Model: C-P1 Duplex unit		Date: 22-Feb-10	No.: RG361001
Subject: Duplex jam		Prepared by: Y. Murata	
From: 2nd Overseas Tech. Support Sec., 2nd PQM Dept.			
Classification:	<input checked="" type="checkbox"/> Troubleshooting	<input checked="" type="checkbox"/> Part information	<input type="checkbox"/> Action required
	<input type="checkbox"/> Mechanical	<input type="checkbox"/> Electrical	<input type="checkbox"/> Service manual revision
	<input checked="" type="checkbox"/> Paper path	<input type="checkbox"/> Transmit/receive	<input type="checkbox"/> Retrofit information
	<input type="checkbox"/> Other ( )		<input checked="" type="checkbox"/> Tier2

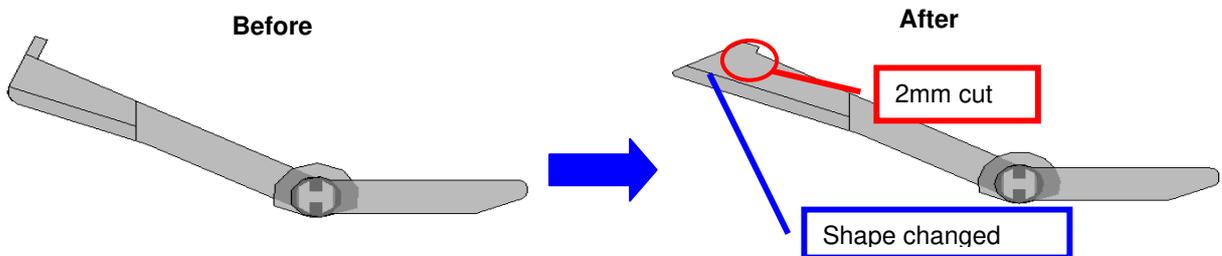
After jammed paper is removed following a misfeed, the “Remove Misfeed Duplex Unit” display does not clear.

The sensor feeler sometimes contacts the inside of the machine frame, damaging the feeler. This can happen if the operator lifts up the unit while pulling it out, or if a Z-fold jam has occurred.

The shape of the feeler was changed so that it does not contact the frame in such cases.

G3612810

**G8932810**
